To: City of Bay St. Louis Planning & Zoning Commission

From: Joshua Magee, 419 Webster St., Bay St. Louis, MS 39520

Re: Public Comment on Proposed Developments – 450 Webster Street Development Company
Major Site Plan Review

Date: 10/12/2026

U.S. Geological Survey Quadrangle Map confirms 450 Webster is an SFHA floodway.

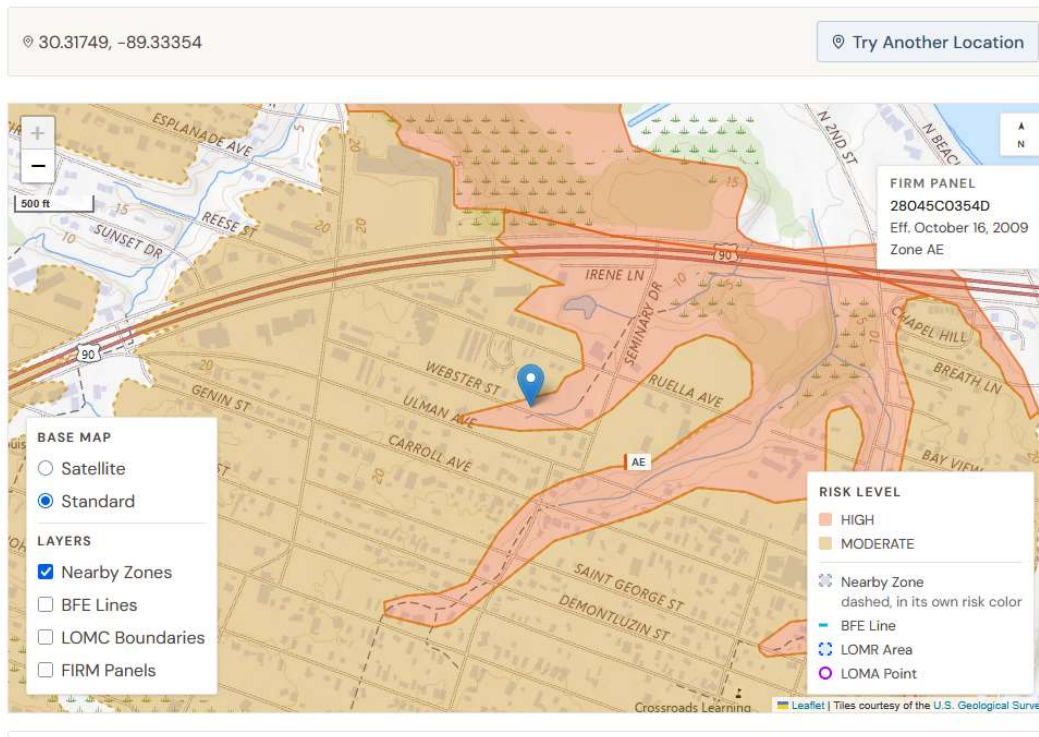
2. Floodplain and Fill Concerns

The 450 Webster site lies within a major floodplain and SFHA. Over the years, the city has allowed significant fill and development in this area without adequate compensatory storage or drainage mitigation, increasing flood risk to existing homes—including mine.

- A detailed floodplain development plan
- A No-Rise or No-Adverse-Impact analysis (the applicant states the NAI will be provided **after** approval)
- Appropriate stormwater management and drainage study
- Documentation of compensatory storage for the **10 feet of proposed vertical fill**
- Confirmation of compliance with the city's flood ordinance and FEMA NFIP standards

This development proposes **10 feet of vertical fill**.

Floodways are extremely hazardous due to velocity, debris, and erosion potential. Encroachments—including fill—are **prohibited** unless certified by a registered professional engineer demonstrating **no increase in flood levels**. (Ord. No. 615-04-2017, art. 5(§ B), 4-13-2017)
